ADDENDUM NO. 1

RE: Item #1, June 3, 2026 Letting - P TAPU(47), PCN 09QH, Pennington County - Grading, PCC Sidewalk & Culverts

SD DOT	PROJECT	SHEET	TOTAL SHEETS
	P TAPU(47)	48	112

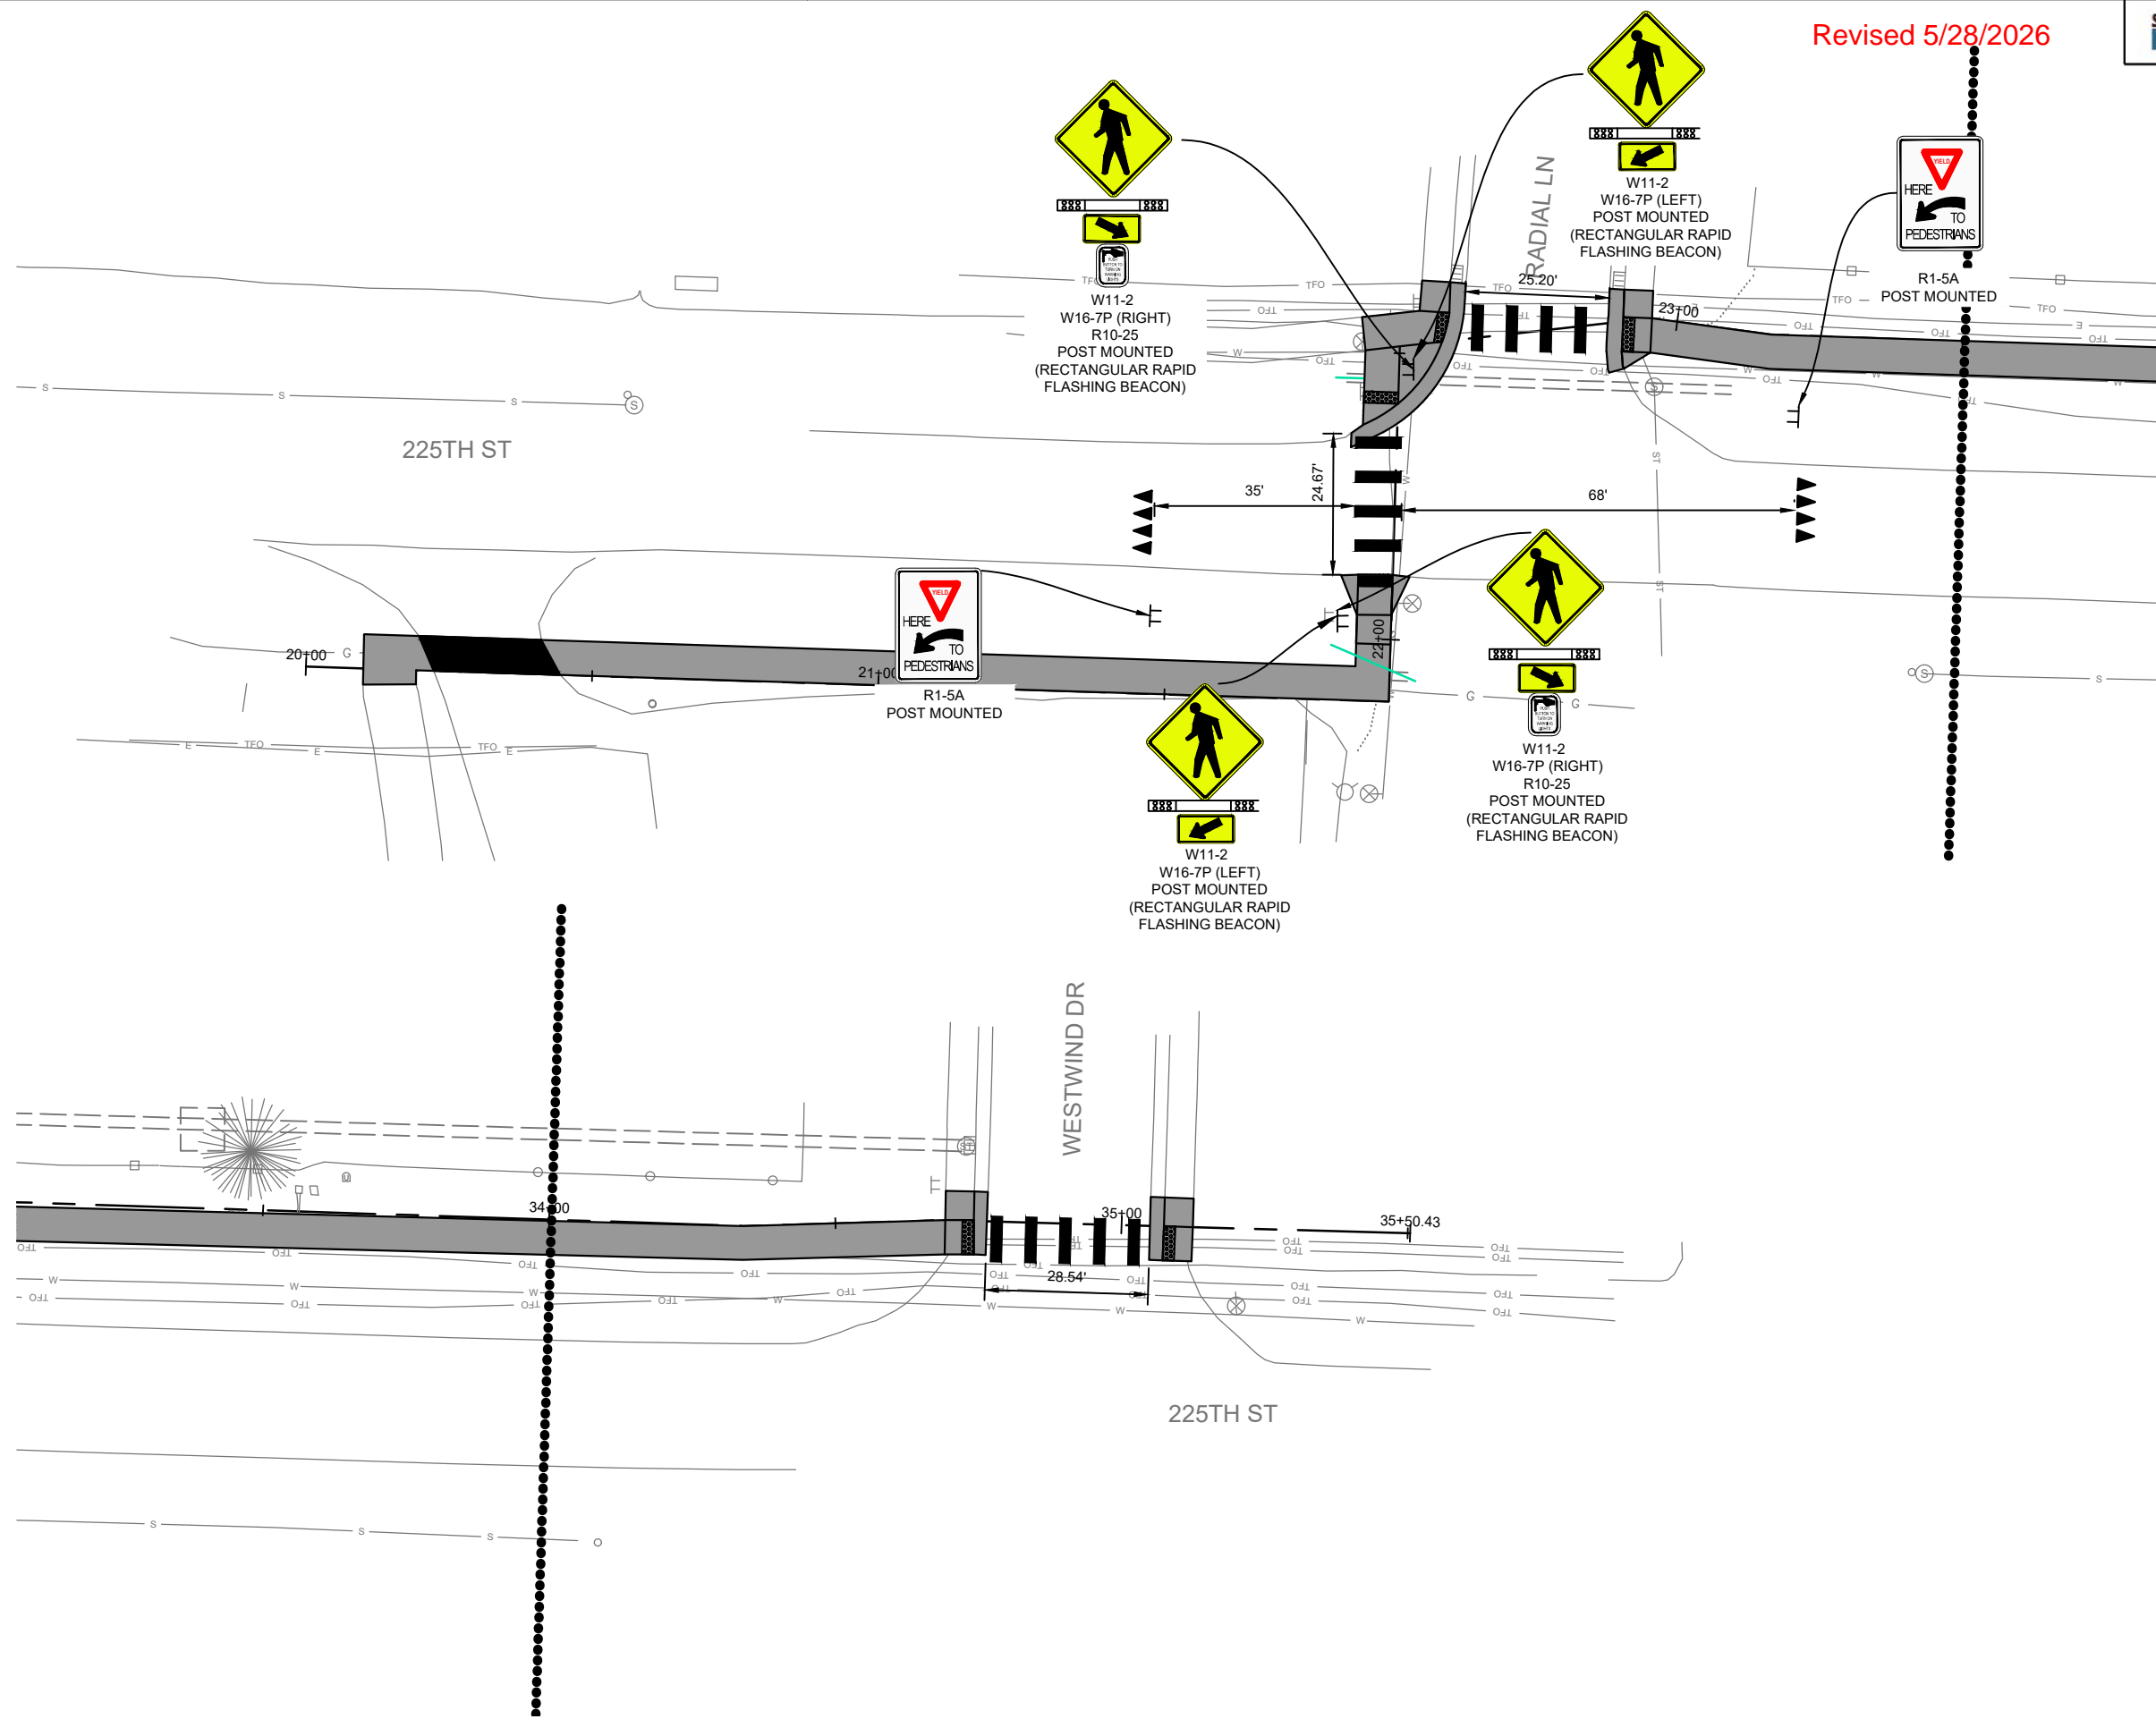
Sheets 47-49: QUANTITIES THIS SHEET notes were revised.

COLD APPLIED PAVEMENT MARKING 24" WHITE	61 FT
2" X 2" PERFORATED TUBE POST	22 FT
RECTANGULAR RAPID FLASHING BEACON	2 EA
FLAT ALUMINUM SIGN, NONREMOVABLE COPY SUPER/ VERY HIGH INTENSITY	18 SF
COLD APPLIED PAVEMENT MARKING, SYMBOL	2 EA

SD DOT	PROJECT	SHEET	TOTAL SHEETS
	P TAPU(47)	50	112

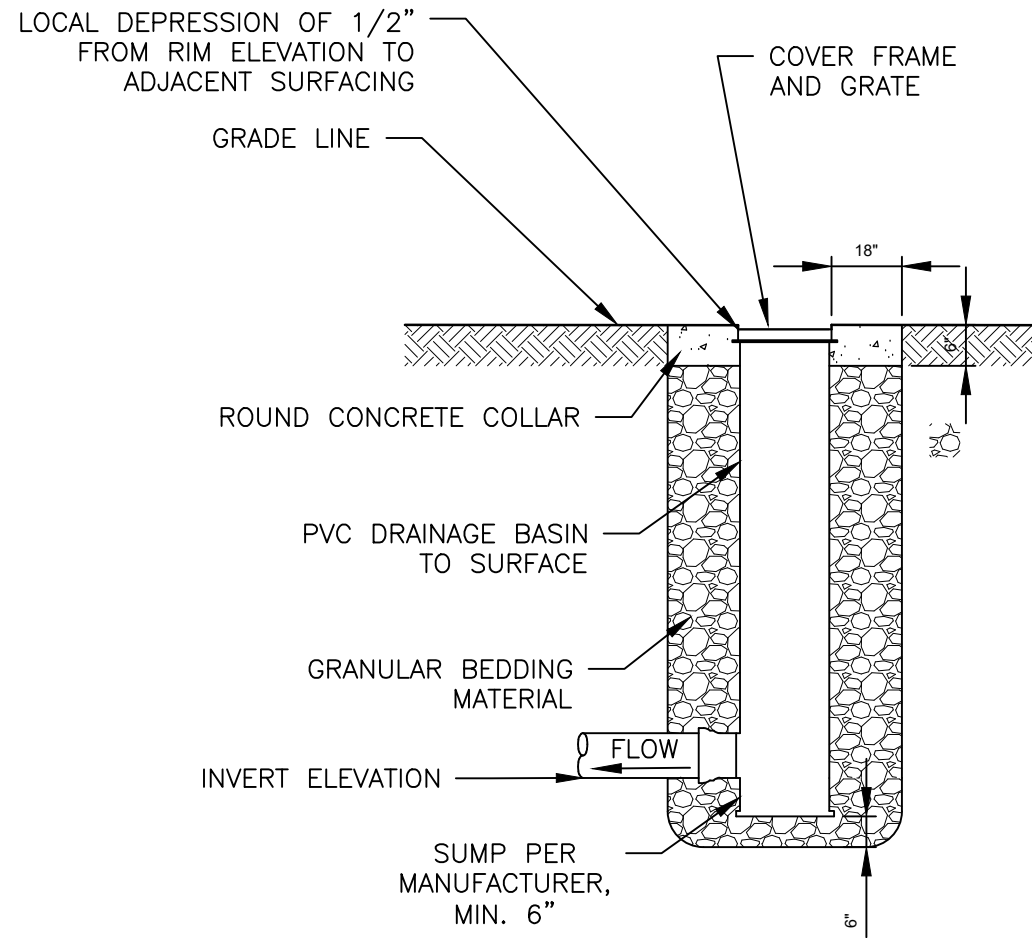
Sheet 50: 12" AREA DRAIN details for CULVERT WITH STANDARD END SECTION RIPRAP were removed.
